LAURELWOOD PARK SOUTH SUBDIVISION

TRACT A - PARK & DRAINAGE MANAGEMENT AREA
WITHIN EL RANCHO ATRISCO SUBDIVISION PHASE III
TOWN OF ATRISCO GRANT, ALBUQUERQUE, BERNALILLO
COUNTY, NEW MEXICO
DECEMBER 2002

ENGINEER'S NATIVE
SITE PLAN AMENDMENT
PROJECT NO. 1001717
APPLICATION NO. 05-00013
Increase max. bldg size
Use Tract A-1 for 0.47
acre of required open space
S. Matson 1/28/05
CITY PLANNING DIRECTOR DATE

TITLE: SITE DEVELOPMENT PLAN

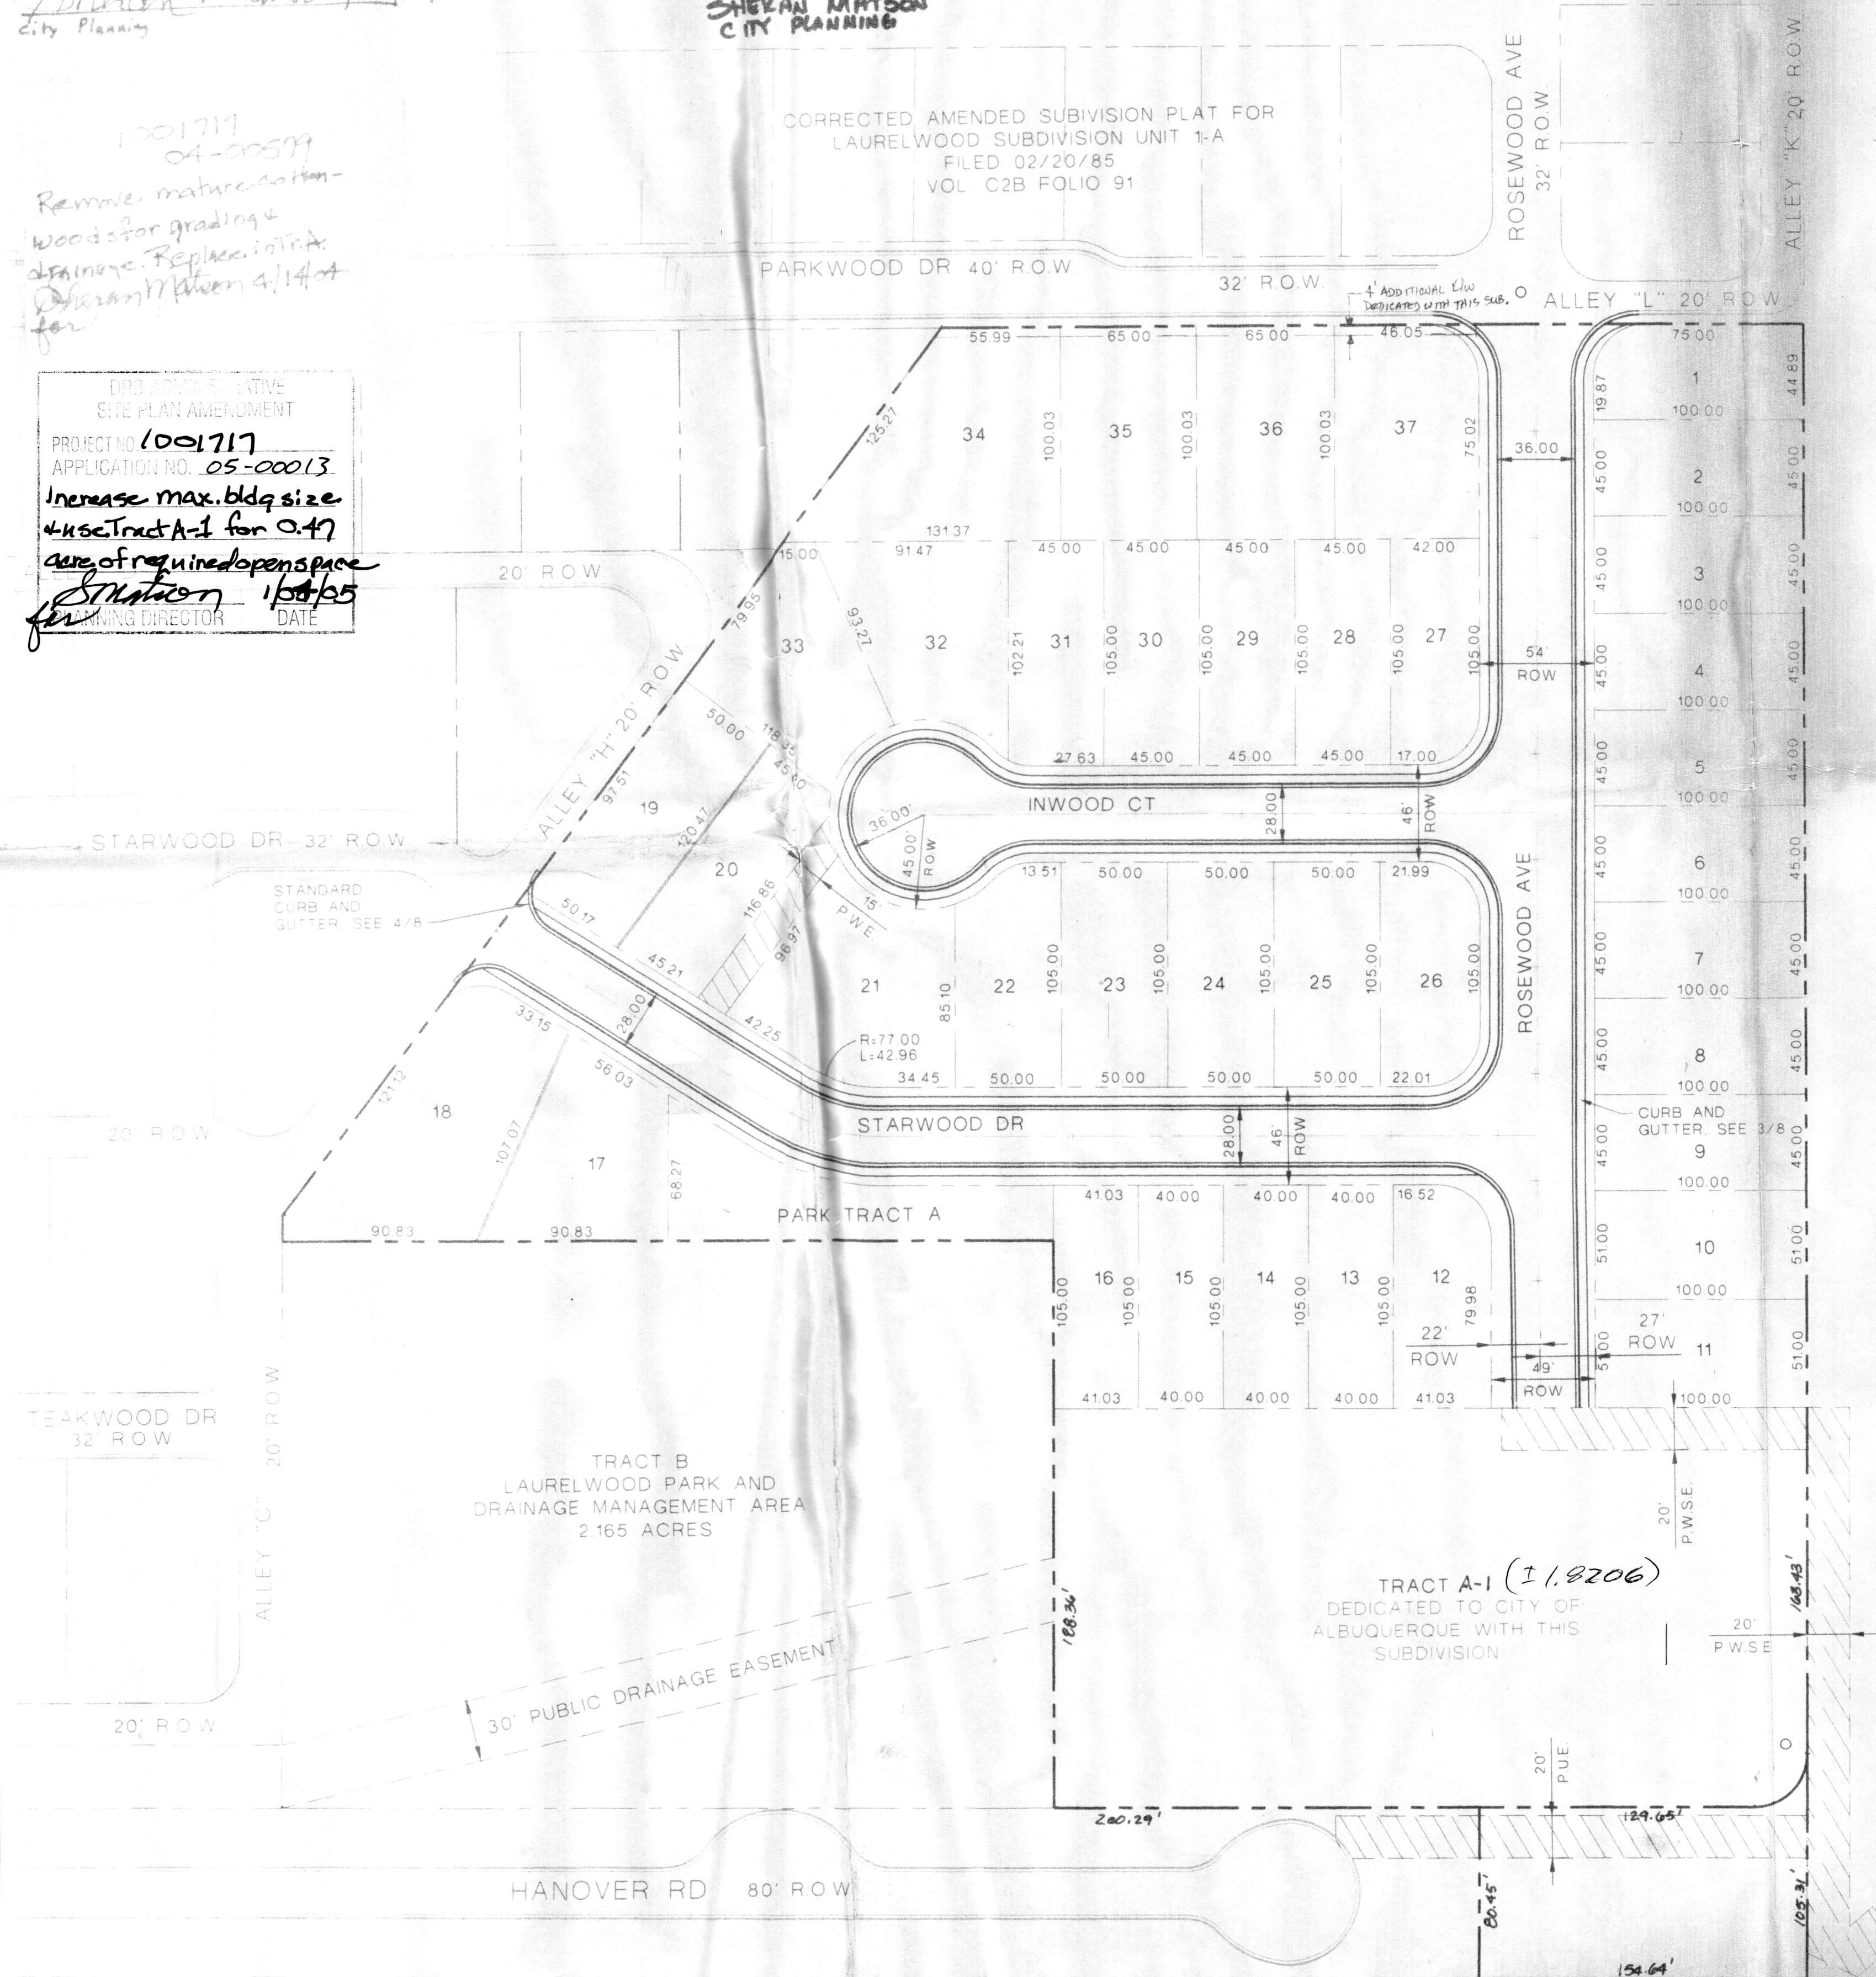
1001717
04-00599
Remove mature cotton-
wood for grading &
drainage. Replace with
Ashran Nation 4/14/04
for

Landscape Plan

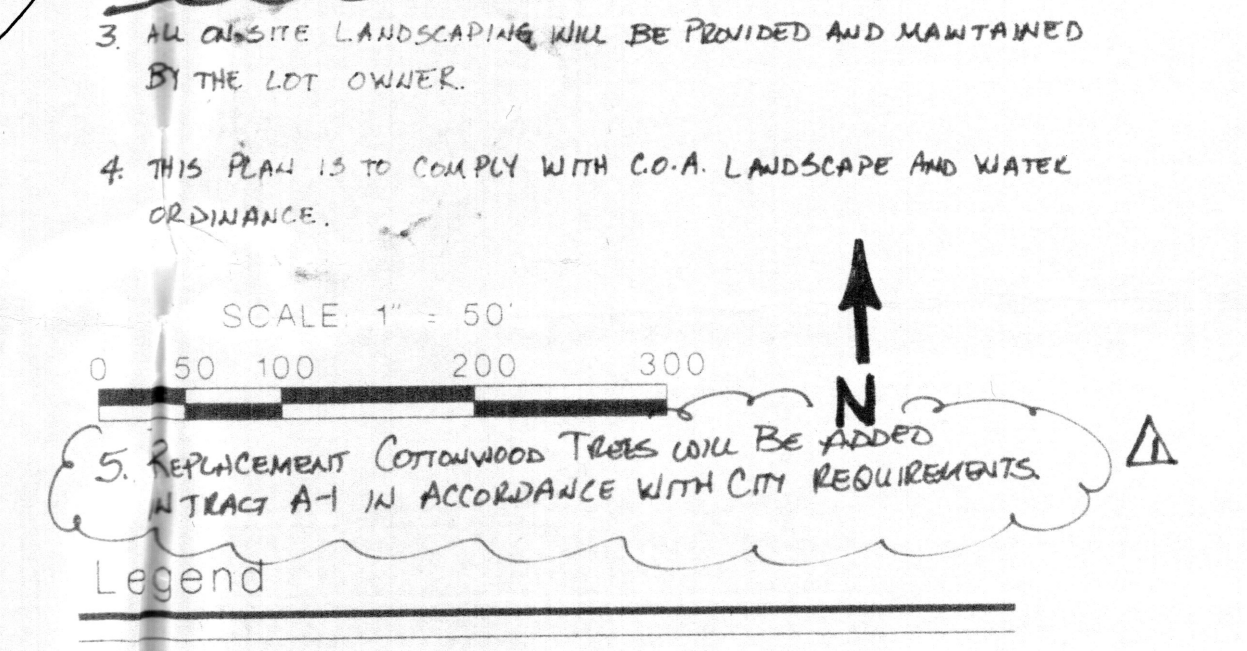
1. ALL EXISTING TREES REQUIRE REMOVAL MAP

2. ADD NOTE FOR TREE REPLACEMENT
